AMENDMENTS TO THE DRAWINGS

Remarks

FIG. 1

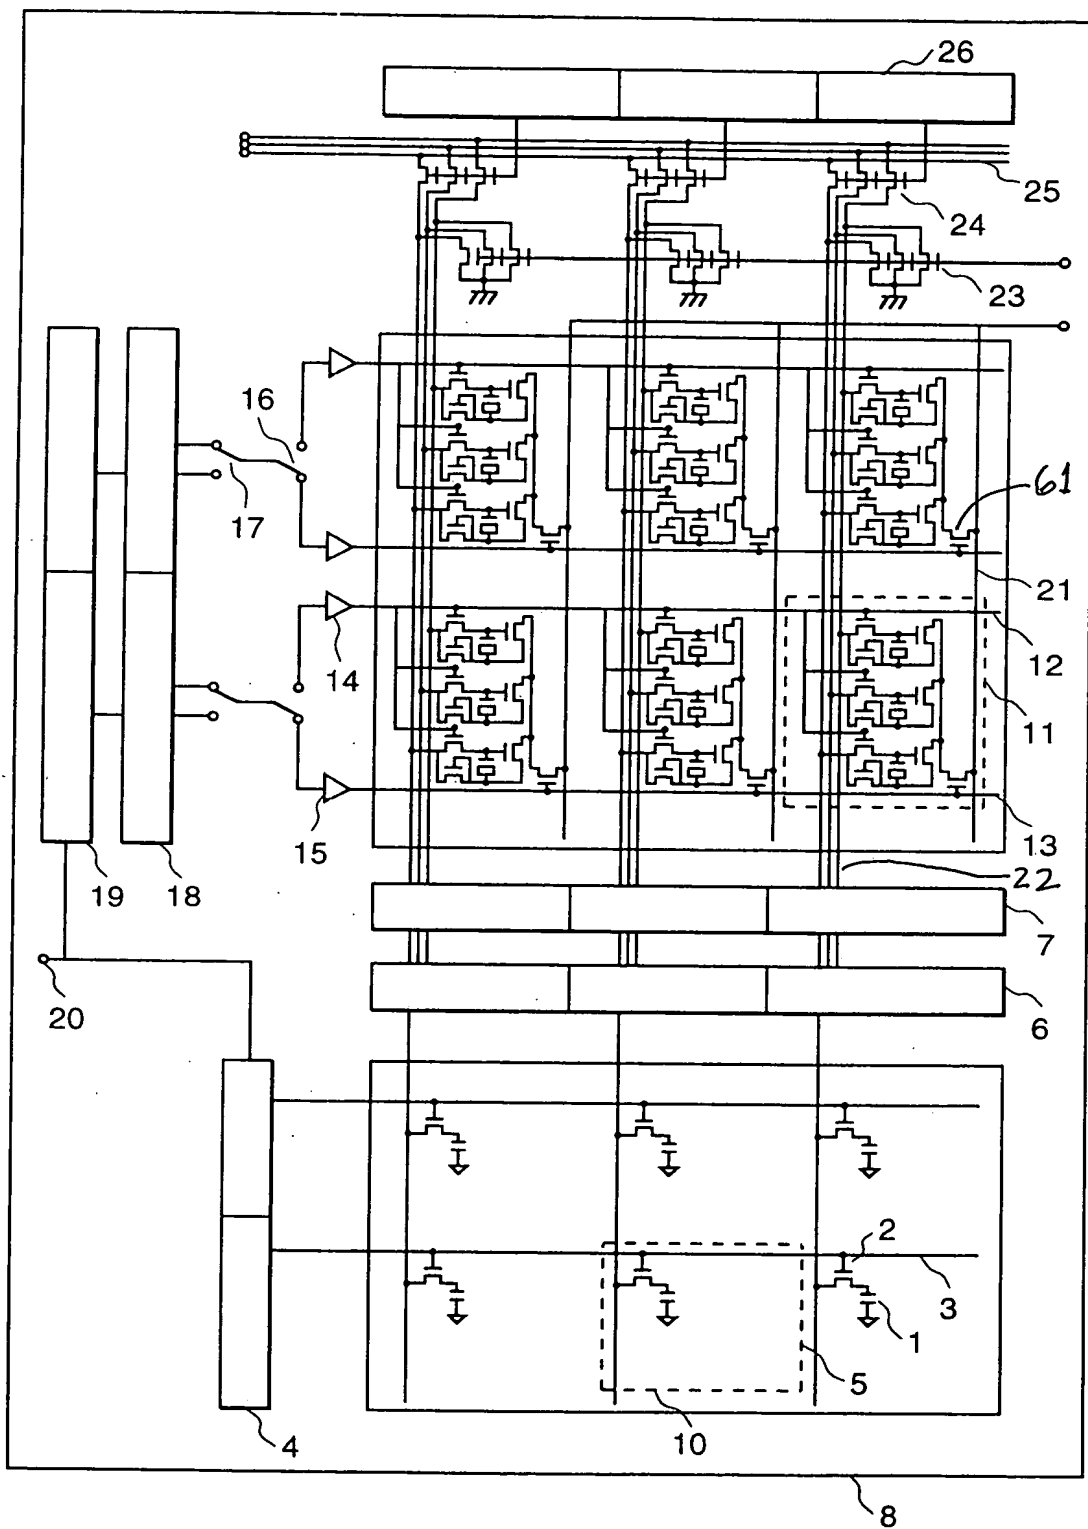
In Fig. 1, the referred to read-out switch 61 in paragraphs [0045], [0050], etc., in the Substitute Specification, is now labeled therein; also in Fig. 1, the described data lines 22, referred to on page 8, paragraph [0032], is now labeled in Fig. 1 (this is also consistent with Fig. 7 of the drawings and the related description thereto).

FIG. 10

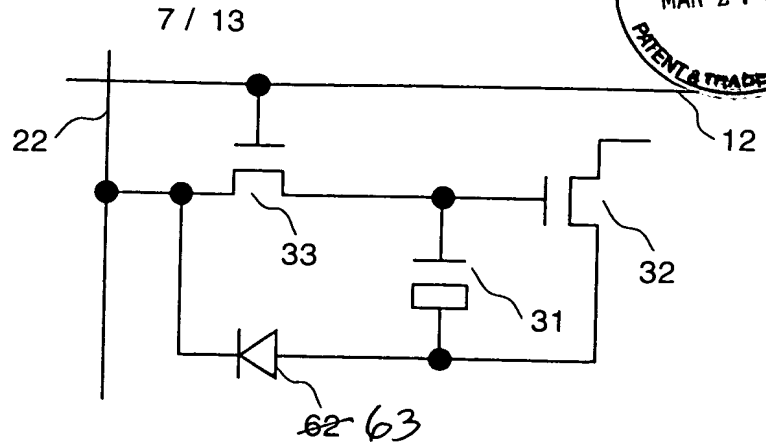
In Fig. 10, diode 62 was re-labeled as 63. (This change was effected to avoid conflict with the numerical character 62 which represents the memory cell in Fig. 9.)

FIG. 11

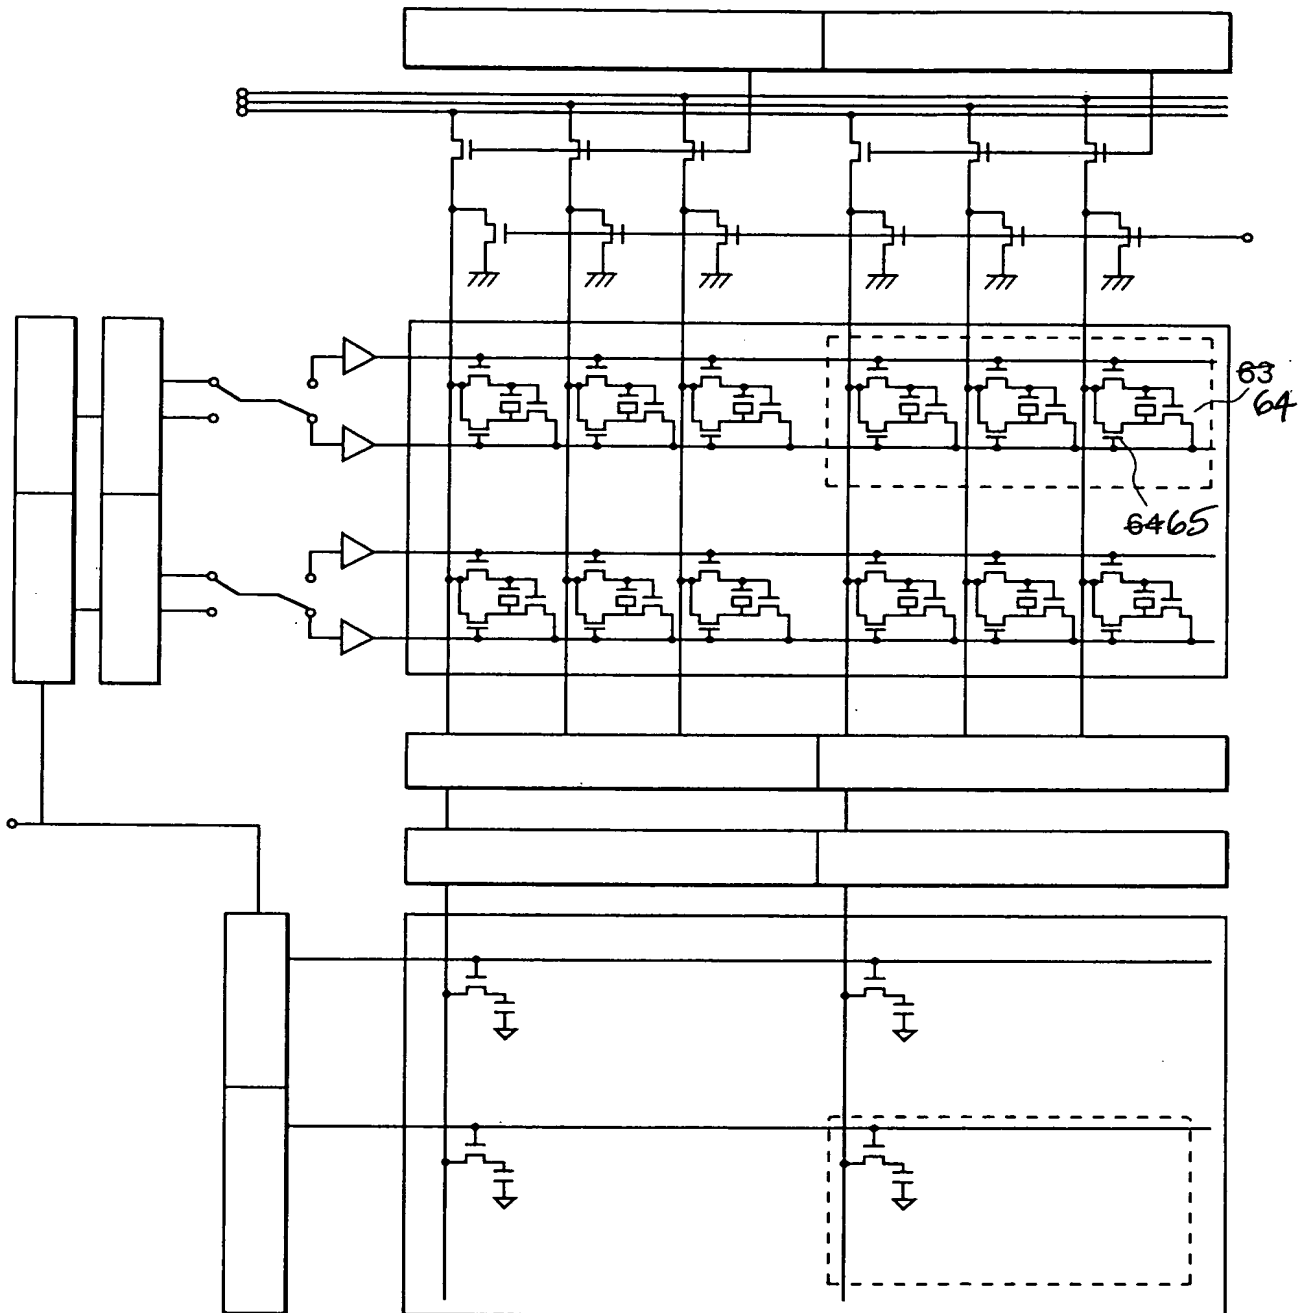
In Fig. 11, numerals 63 and 64 were replaced with numerals 64 and 65, respectively. (These changes were made in view of the change effected in Fig. 10.)
